George Vanderheyden
Vice President
Calvert Cliffs Nuclear Power Plant
Constellation Generation Group, LLC

SUBJECT: Calvert Cliffs Nuclear Power Plant
Unit Nos. 1 & 2; Docket Nos. 50-317 & 50-318
License Amendment Request: Improvement to the Definition of Operations
Involving Positive Reactivity Changes

Attachments: (1) Discussion and Analysis of the Proposed Changes
(2) Technical Specification Marked-up Pages
(3) Final Technical Specification Pages

3.4.6 RCS Loops - MODE 4

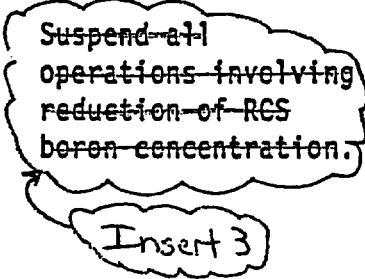
a. ~~No operations are permitted that would cause reduction of the RCS boron concentration; and~~

Insert 5

4. Revised LCO 3.4.6, Note 1.a to state, "No operations are permitted that would cause introduction of coolant into the RCS with boron concentration less than required to meet the SDM of LCO 3.1.1; and". This note is applicable in Mode 4 when all reactor coolant pumps and shutdown cooling (SDC) pumps are not in operation for \leq one hour per eight hour period. Boron concentrations that are not accounted for in the SDM of LCO 3.1.1 will not be allowed so that, when circulation is re-established, SDM in the system will not be adversely affected. The proposed note will allow boron concentration fluctuations associated with inventory management.

3.4.7 RCS Loops - MODE 5, Loops Filled

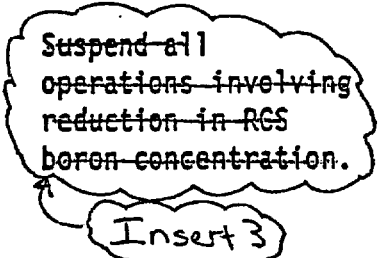
a. ~~No operations are permitted that would cause reduction of the RCS boron concentration; and~~

Insert 5

6. Revised LCO 3.4.7, Note 1.a to state, "No operations are permitted that would cause introduction of coolant into the RCS with boron concentration less than required to meet the SDM of LCO 3.1.1; and". This note is applicable in Mode 5 when the RCS loops are filled, when the SDC pump of the loop in operation is not in operation for \leq one hour per eight hour period. Boron concentrations that

3.4.17 Special Test Exception (STE) RCS Loops - MODES 4 and 5

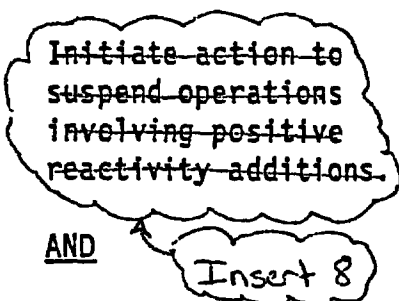
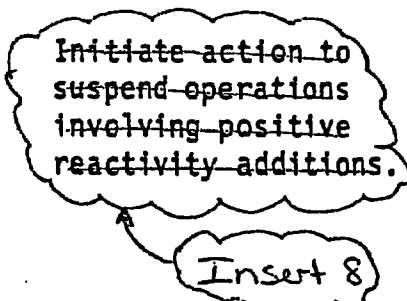
- a. Xenon reactivity is $\leq 0.1\% \Delta k/k$ and is approaching stability;
- b. No operations are permitted which could cause ~~reduction~~ of the RCS boron concentration; *with* *Insert 7* *introduction of coolant into*
- c. The charging pumps are deenergized and the charging flow paths are closed; and
- d. The SDM requirement of LCO 3.1.1 is verified every 8 hours.

14. Revised LCO 3.4.17, Note b to state, "No operations are permitted that would cause introduction of coolant into the RCS with boron concentration less than required to meet the SDM of LCO 3.1.1; ". This note is applicable in Modes 4 and 5. The note allows suspending the reactor coolant circulation requirements of LCO 3.4.6, LCO 3.4.7, and LCO 3.4.8 to conduct local leak rate testing on Containment Penetration 41 or to permit maintenance on the valves in the SDC common suction line. Containment Penetration 41 local leak rate test consists of pressurizing the SDC return line between the containment penetration isolation valves, a process that requires the SDC loop to be shut down. Likewise, maintenance on the suction piping or valves common to both SDC loops requires the SDC system to be shut down. This LCO is a special test exception that is allowed even though there is no bounding safety analysis. The tests or maintenance are allowed since they are performed under close supervision during the test program and must stay within the requirements of the LCO. Boron concentrations that are not accounted for in the SDM of LCO 3.1.1 will not be allowed so that, when circulation is re-established, SDM in the system will not be adversely affected. The proposed note will allow boron concentration fluctuations associated with inventory management.
